RECEIPT DATE: 4/5/18 **ONSITE SEWAGE DISPOSAL SYSTEM** P 562950

PROPERTY ADDRESS: 13780 Triadelphia Mill Road

**ONSITE SEWAGE DISPOSAL SYSTEM DESIGN PLAN**  
**ORNDORFF PROPERTY**  
**SABINE PROPERTY - LOT 2**  
 13780 TRIADELPHIA MILL ROAD  
 CLARKSVILLE, MD 21029  
 10.29 AC.  
 BUILDING PERMIT #

**PERCOLATION CERTIFICATION REVISION PLAN**

**TRENCH/DRAINFIELD DATA**

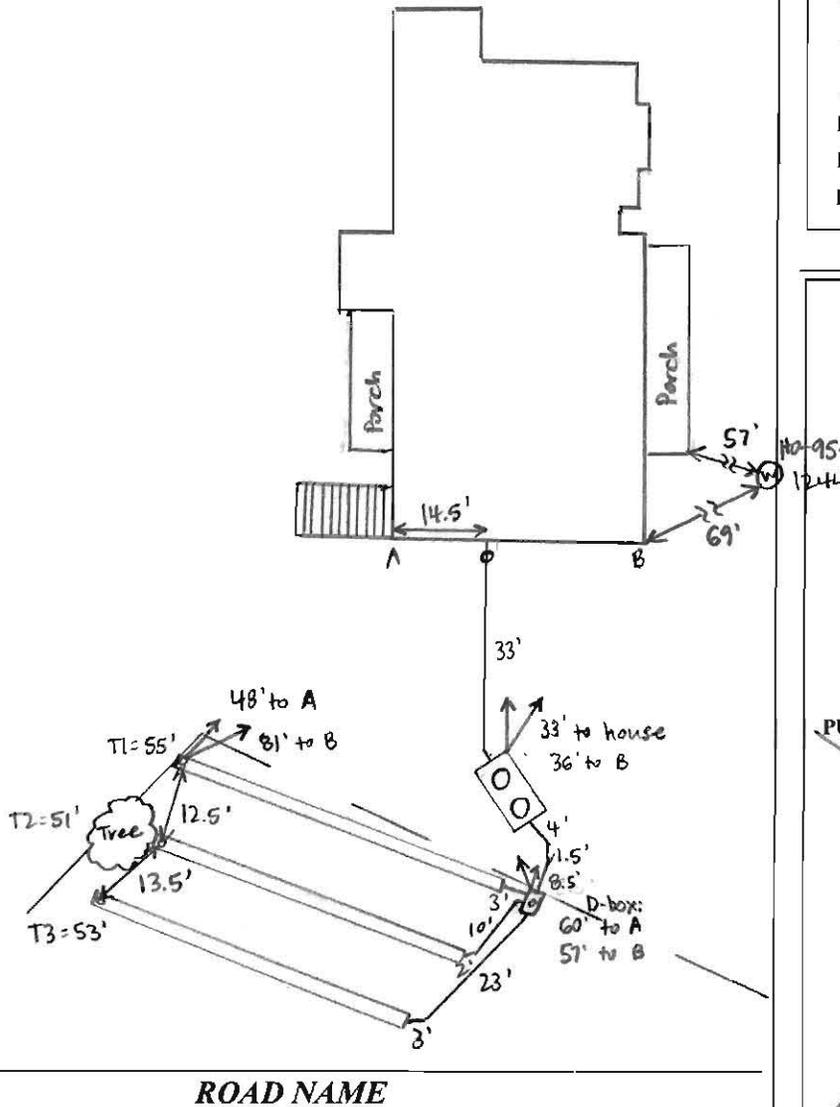
7/23/18 Met S. Carroll on site for layout. SDA corner stakes present, tank not staked. House connection is on side of house closest to SDA - builder + owner on site and would like to move tank past retaining wall, >100' from well. OK to change tank location. Existing tank from old house filled with water - must be pumped by a septic hauler + filled with dirt prior to install. S. Carroll will also locate existing trench prior to layout of trenches. (SC) 8/3/18

S. Carroll exposed existing trench. Laid out 3 x 53' trenches on contour - OK for T1 to be 56' and T2 to be 50' to keep off tree. House connection made. (SC) 8/6/18 Tank set and connected to house. Old tank pumped + collapsed. (SC) 8/13/18 T1 complete - left open @ ends for inspection. 3' wide, 2.5' to stone. S. Carroll adding stone to T2. (SC) 8/14/18 T3 complete, left open for inspection. 3' wide, 2.5' to stone. Levelled speed levelers in D-box. (SC)

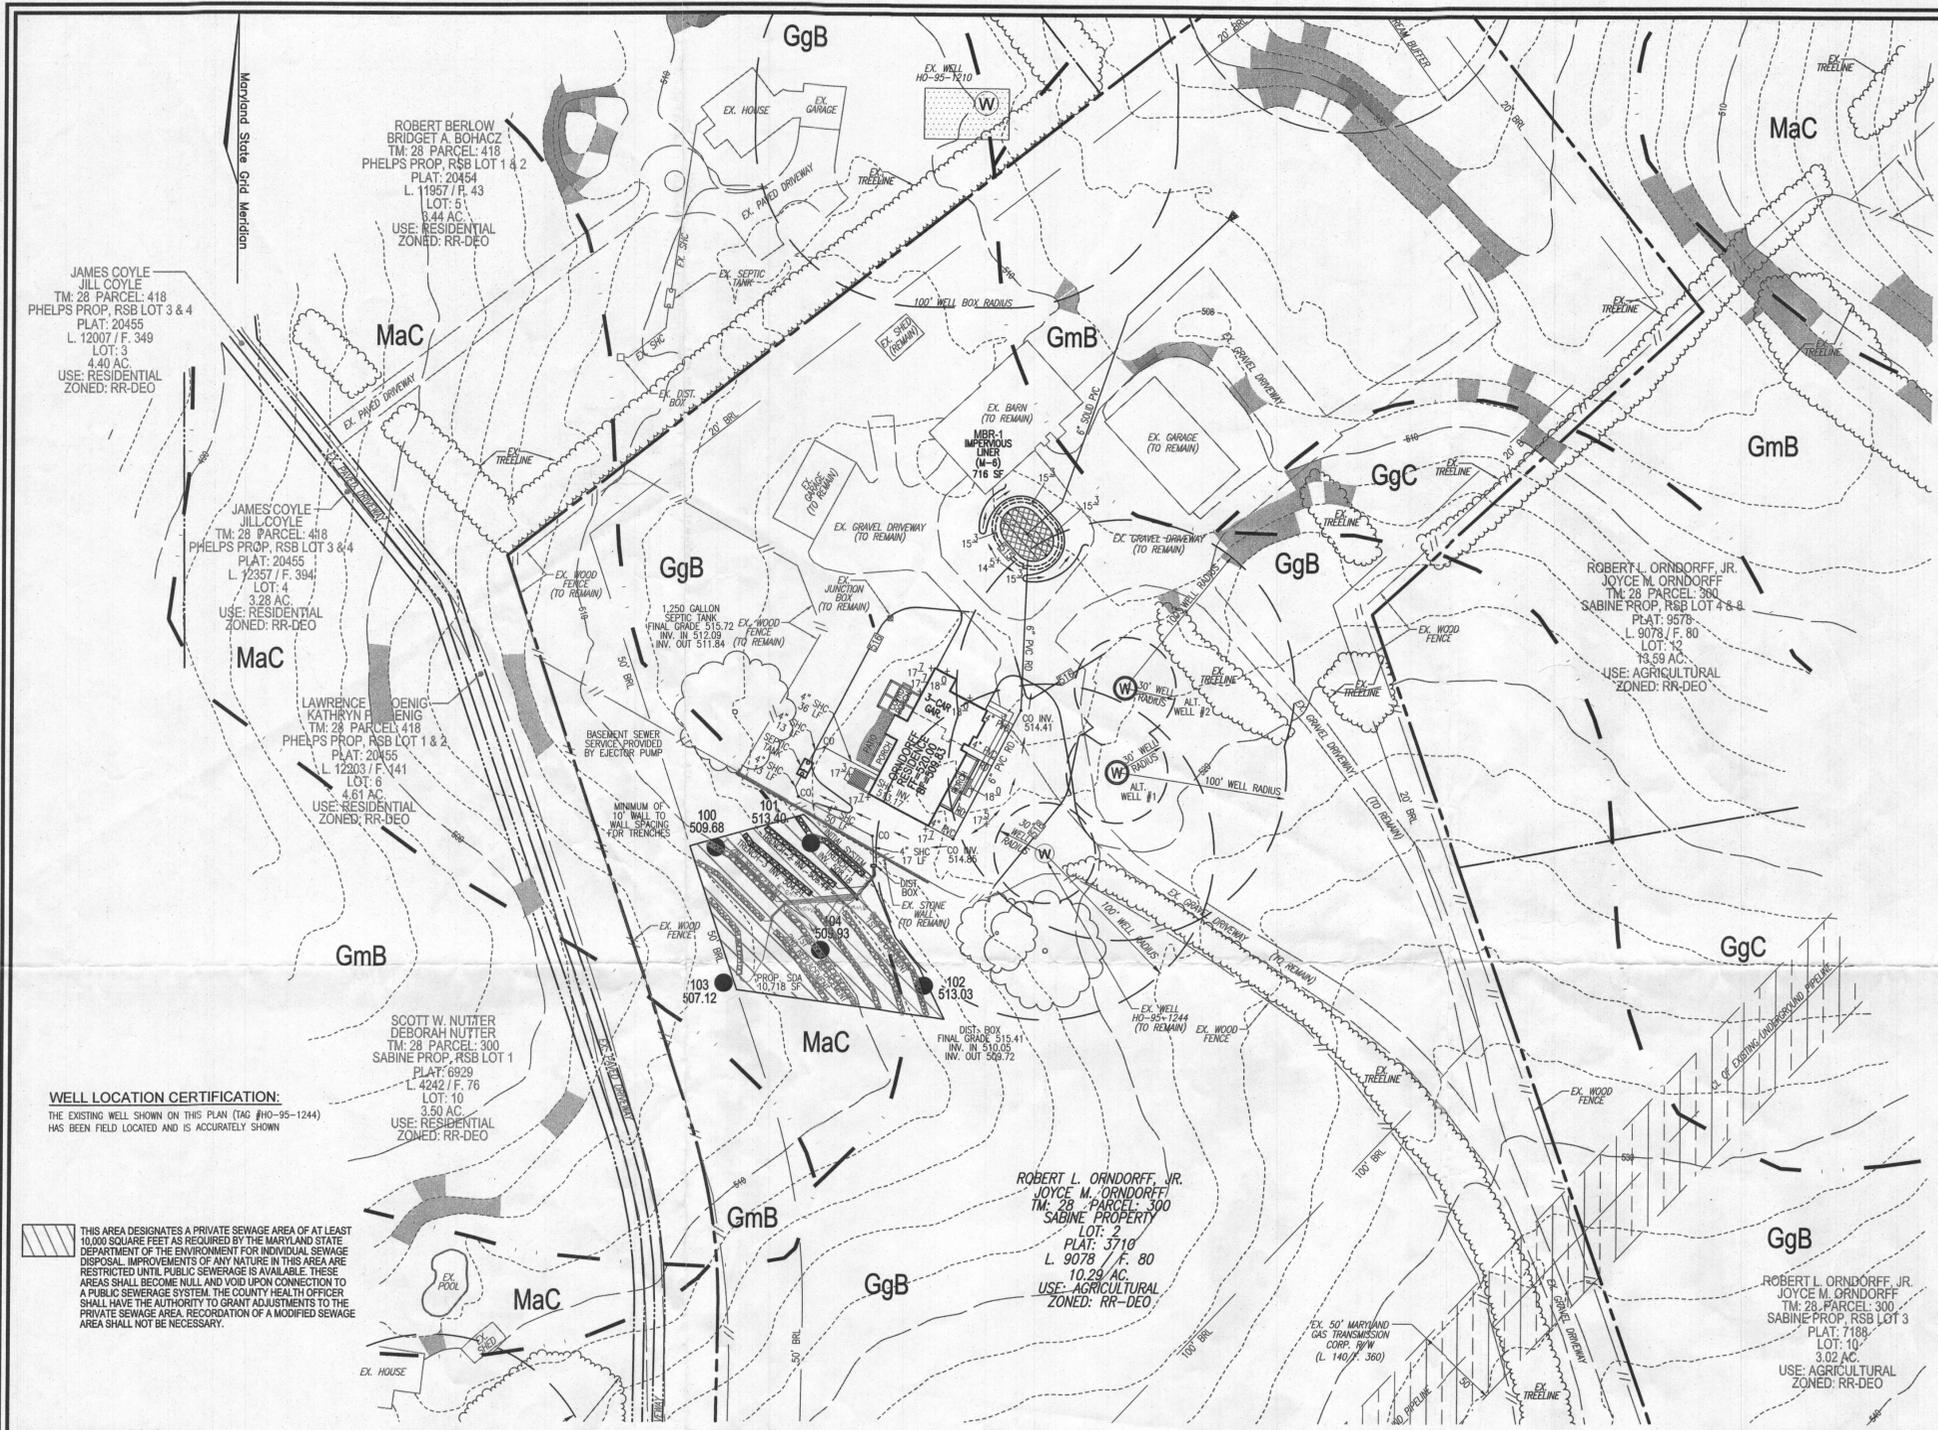
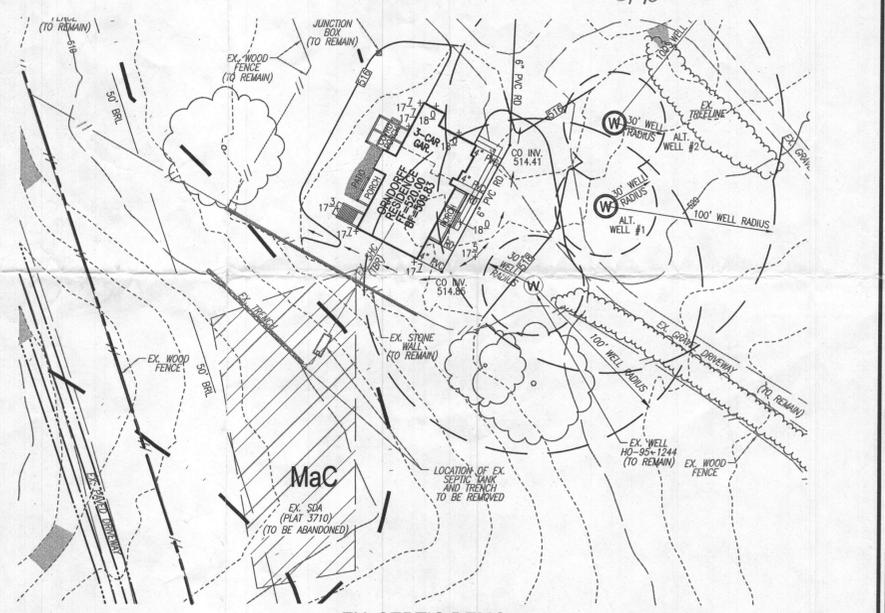
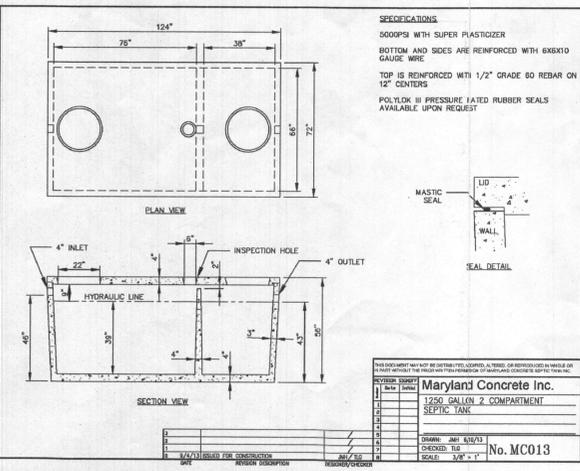
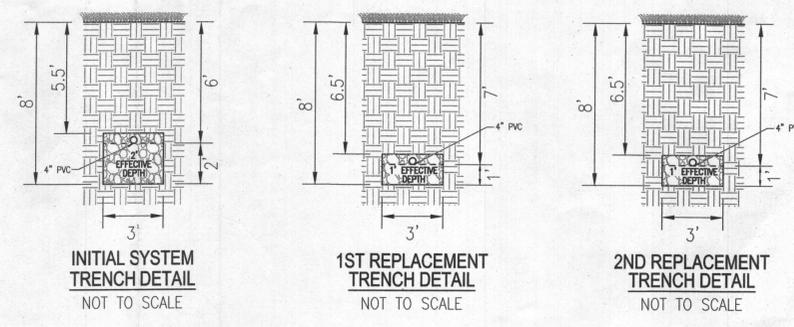
We looked over the plan and the file. We aren't able to justify moving the area out that far without doing additional testing on that side. Unfortunately, we can't allow movement to the other side or down the hill and the well setback prevents any help up the hill. I'm not sure if LPD helps squeeze everything in using unequal length trenches. You could try. Alternatively, you will have to go down to 3 bedrooms or do the additional testing.

Attached is an exhibit showing a rough trench layout and the approved sewage disposal area. The house is a 4 bedroom. For the Initial System, with an absorption rate of 0.8 and 3' wide trenches, a total of 158 LF of trench is required. We have provided 2 trenches of 79 LF in length, for a total of 158 LF. For the First and Second Replacement Systems, both with an absorption rate of 0.6 and 3' wide trenches, a Total of 277 LF of trench is required for each system. For the First Replacement System we provided 3 trenches of 93 LF in length, for a total of 279 LF. For the Second Replacement System we provided 4 trenches of 70 LF in length, for a total of 280 LF. As you can see, we are having to provide a rather large amount of trenching due to the poor absorption rates. And this is only for a 4 bedroom house.

Jeff  
ORNDORFF: The absorption rates are bad and we are having a problem fitting trenches for just 4 bedrooms. Is there any way we can expand enough and not perform additional testing? It seems like there is an issue expanding the existing area. Can we go 5' towards the broad swale? Should we meet to discuss?  
Can Dana authorize the demo?  
Thanks!!!! Rob

I talked to Dana about the demo and we will let that go forward. Just submit a demo release request to our office or let me know if you've already done so. Why don't you send me a pdf of your trench layout with the original area to see how much it overhangs. Try to overhang on the upper and left side more than the right side and not down the hill.

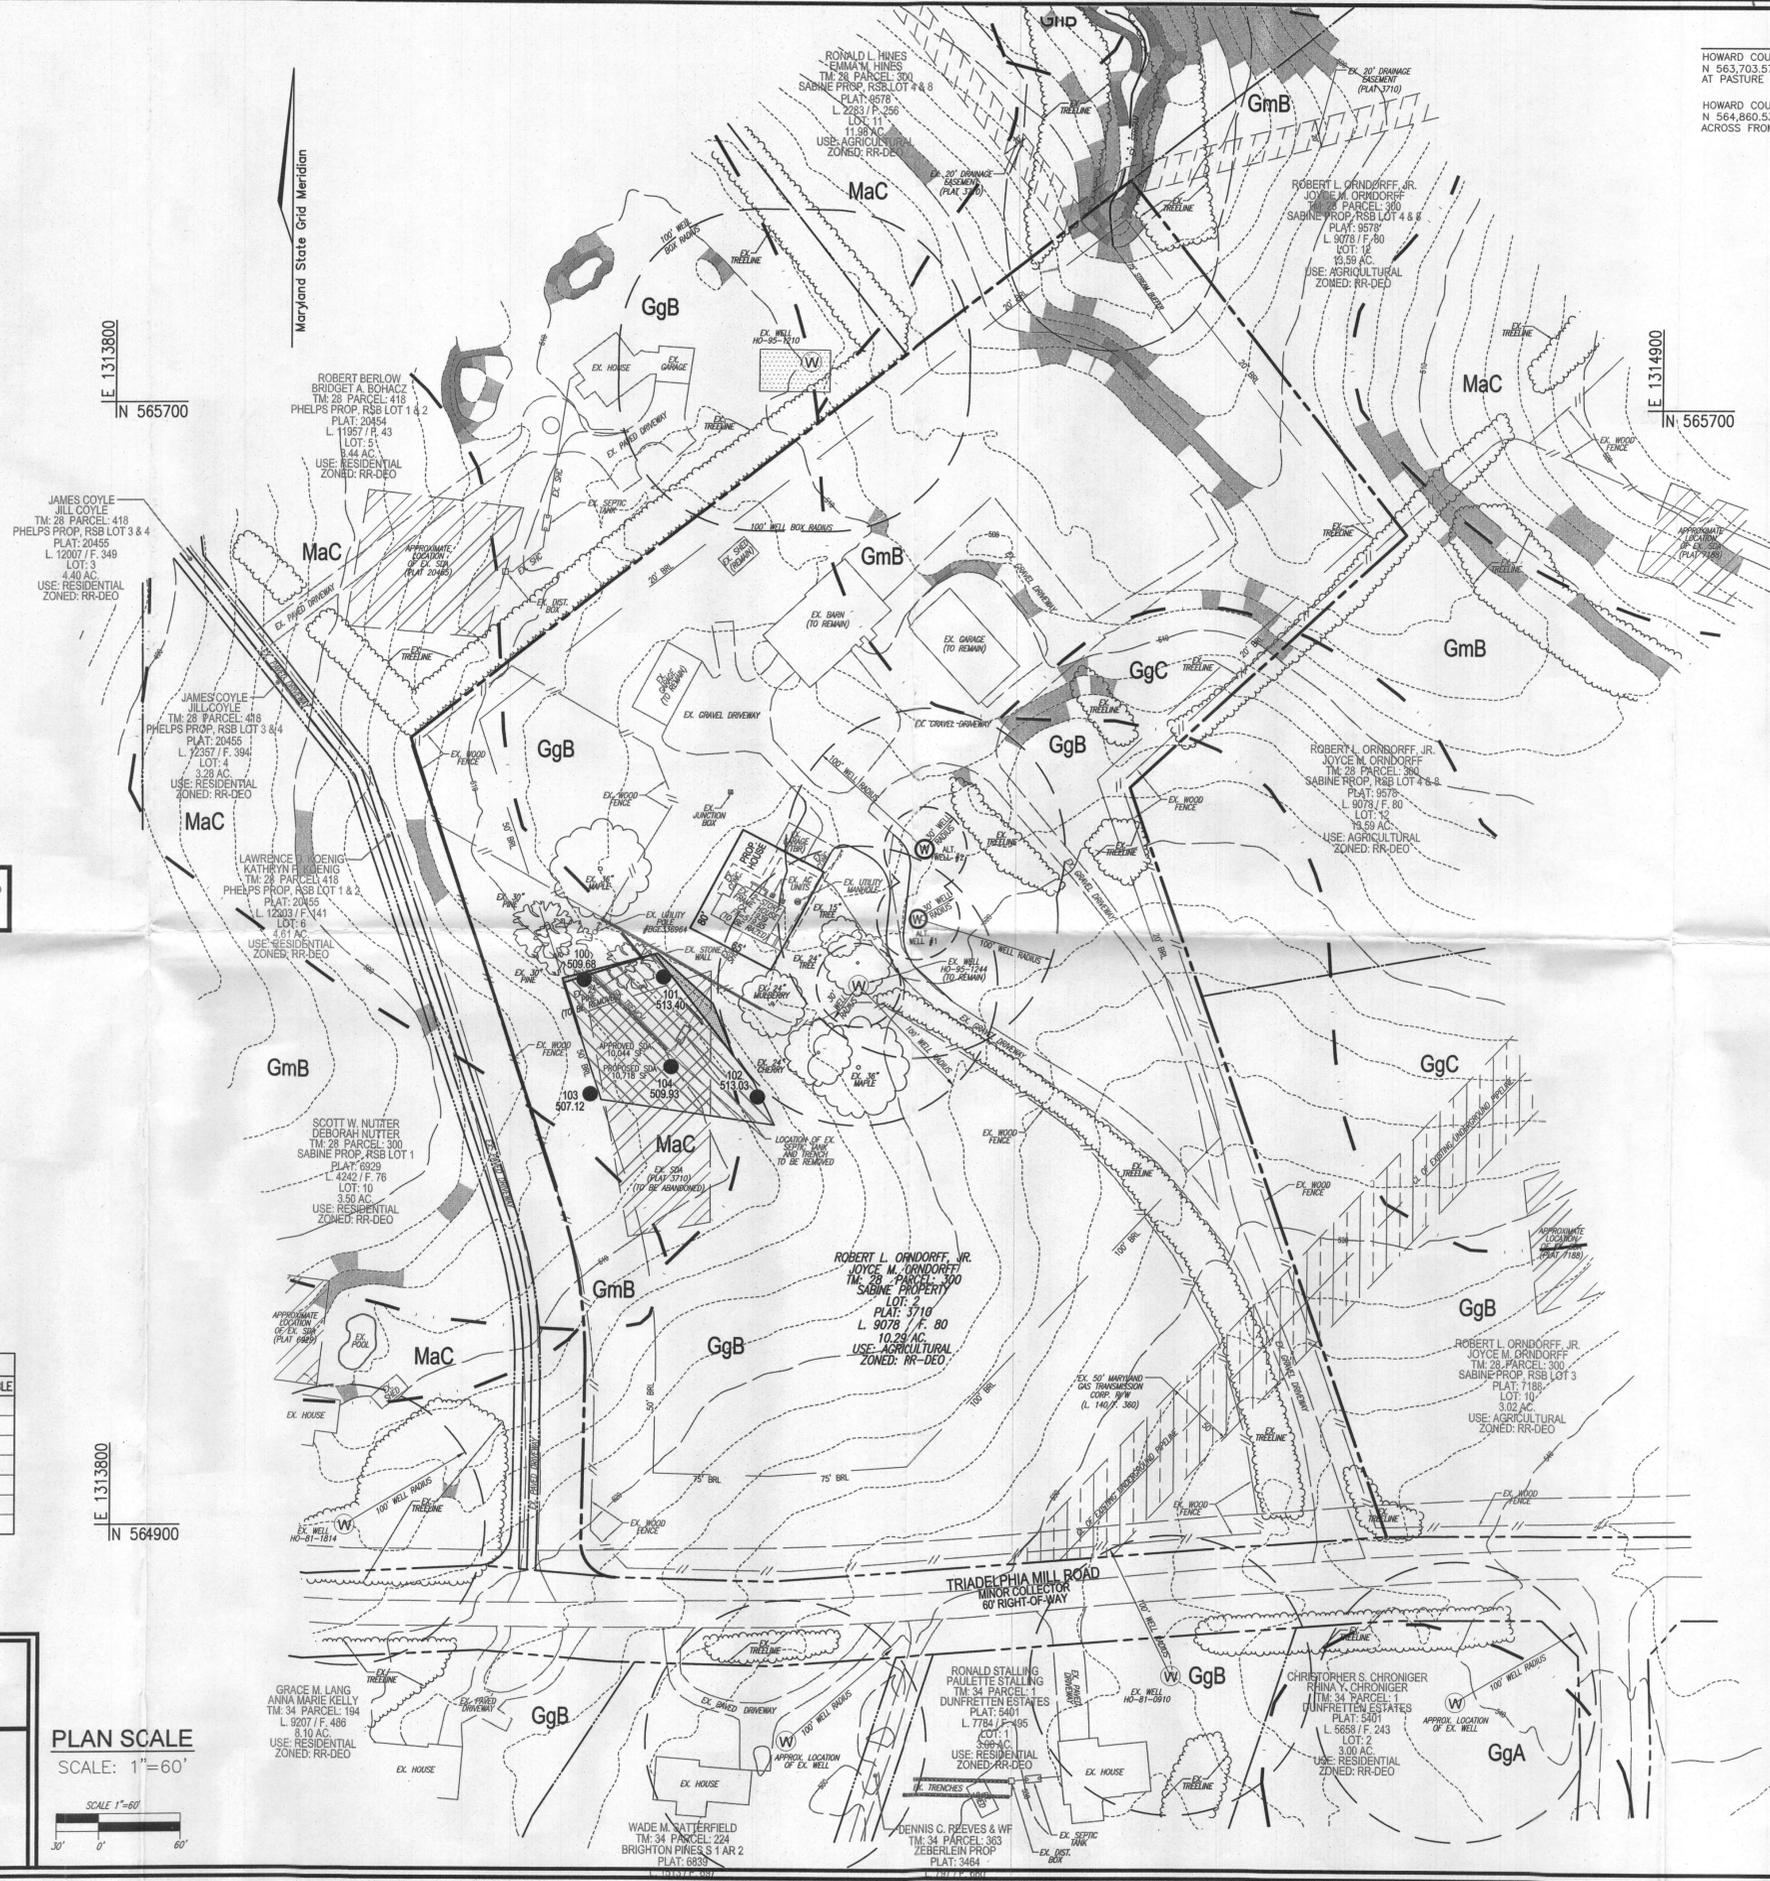
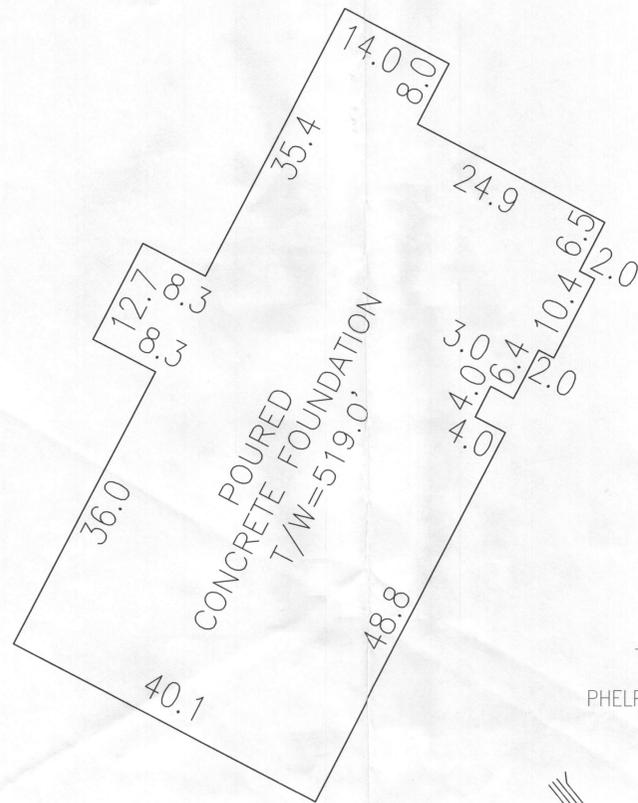
14. THE EXISTING TANK AND TRENCH MUST BE LOCATED AND SHOWN ON THE OSDS PLAN. PROPOSED TRENCHES FOR THREE SYSTEMS TO SERVE THE PROPOSED HOUSE MUST BE SHOWN TO FIT IN THE REMAINING AREA OR THE SDA MAY NEED TO BE REVISED. ADDITIONAL PERCOLATION TESTING MAY BE REQUIRED IN ORDER TO SERVE SDA.

NOTE:  
THE PURPOSE OF THIS PERCOLATION CERTIFICATION REVISION PLAN IS TO EXPAND THE PREVIOUSLY APPROVED SEWAGE DISPOSAL AREA TO ALLOW FOR MORE TRENCHING AREA.
